UNITED STATES PATENT AND TRADEMARK OFFICE

Office Action Summary

10/033,970

HANSEN, KARL

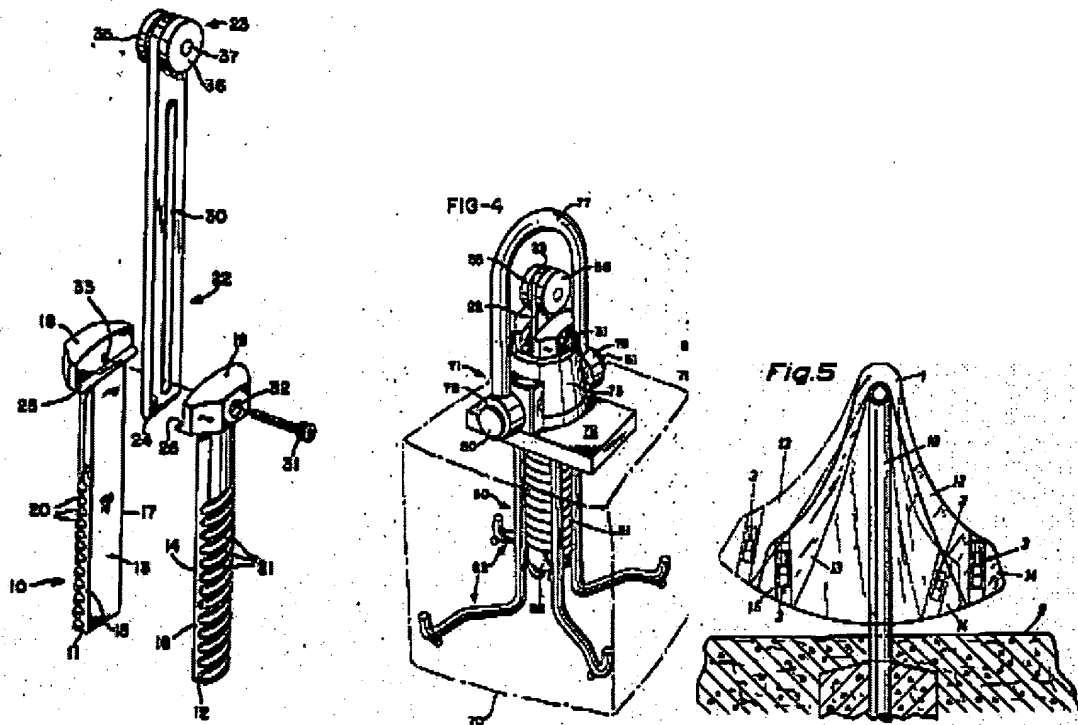
The drawings are objected to because **numerous reference numerals have been used to identify all variations of the same name part. As but one example, a planar element "12" is different variation in all of Figs. 1, 2, and 14-20.** Corrected drawing sheets in compliance with 37 CFR 1.121(d) are required in reply to the Office action to avoid abandonment of the application. Any amended replacement drawing sheet should include all of the figures appearing on the immediate prior version of the sheet, even if only one figure is being amended. The figure or figure number of an amended drawing should not be labeled as "amended." If a drawing figure is to be canceled, the appropriate figure must be removed from the replacement sheet, and where necessary, the remaining figures must be renumbered and appropriate changes made to the brief description of the several views of the drawings for consistency. Additional replacement sheets may be necessary to show the renumbering of the remaining figures. Each drawing sheet submitted after the filing date of an application must be labeled in the top margin as either "Replacement Sheet" or "New Sheet" pursuant to 37 CFR 1.121(d). If the changes are not accepted by the examiner, the applicant will be notified and informed of any required corrective action in the next Office action. The objection to the drawings will not be held in abeyance.

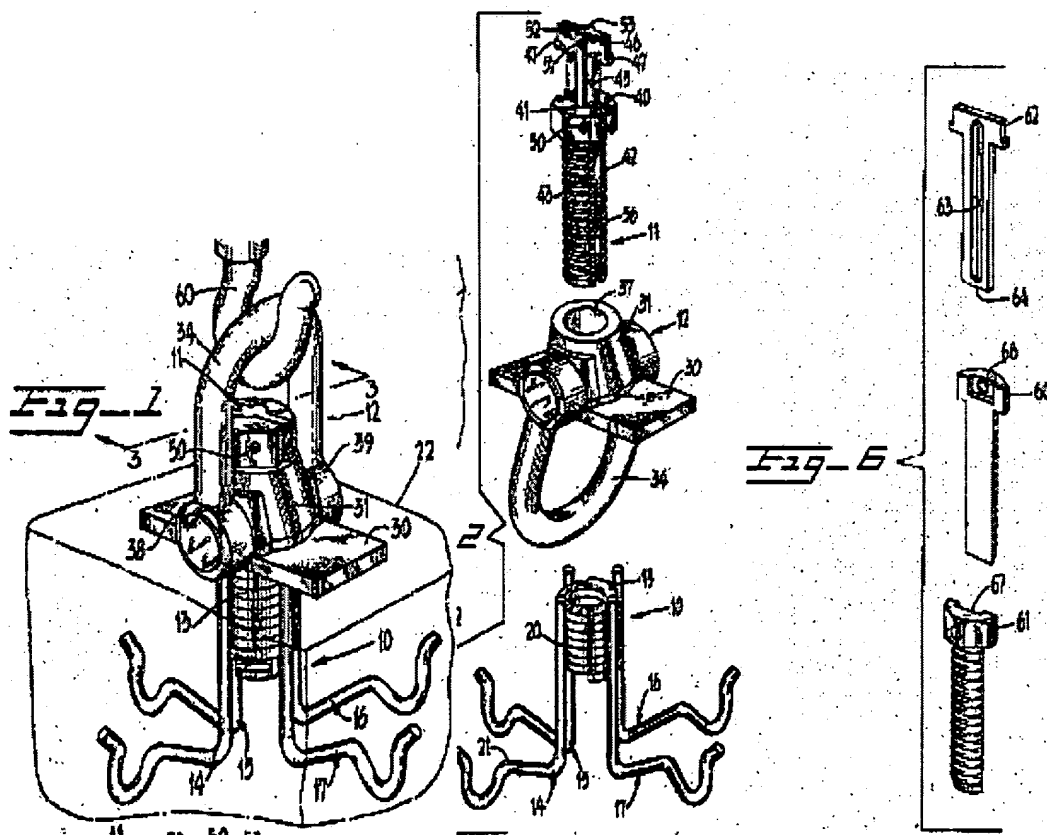
With respect to claim 27, Strong discloses an apparatus for joining two members via a threaded coupling member (Figs. 1, 2, 6) the apparatus comprising a first member (45) having a non circular aperture (63) disposed proximate an edge; an elongate threaded coupling member

(11) having an external thread set (42, 43) and a non-spherical engaging portion (65), the engaging portion (65) preventing rotation of the first member (45) relative to the coupling member (11) when the engaging portion (65) is inserted into the aperture (63) of the first member (45), and a second member (20) having an internal thread set sized to cooperate with the external thread set of the threaded coupling member (11), said internal thread set operatively receiving a portion of both the external thread set of the threaded coupling member (20, 21) and a portion of the first member (45) to secularly bind the first member (45) to the second member (20).

With respect to claims 28-31, Strong discloses (Figs. 1, 4) that the non-circular aperture is a slot aperture (63) having a pair of generally planar walls; wherein the engaging portion (65) includes a pair of generally parallel planar surfaces being in contact with the pair of planar walls of the slot aperture (63) when the engaging portion is inserted into the aperture; wherein the coupling member (65) is T-shaped; and wherein the coupling member (11) includes a pair of co-
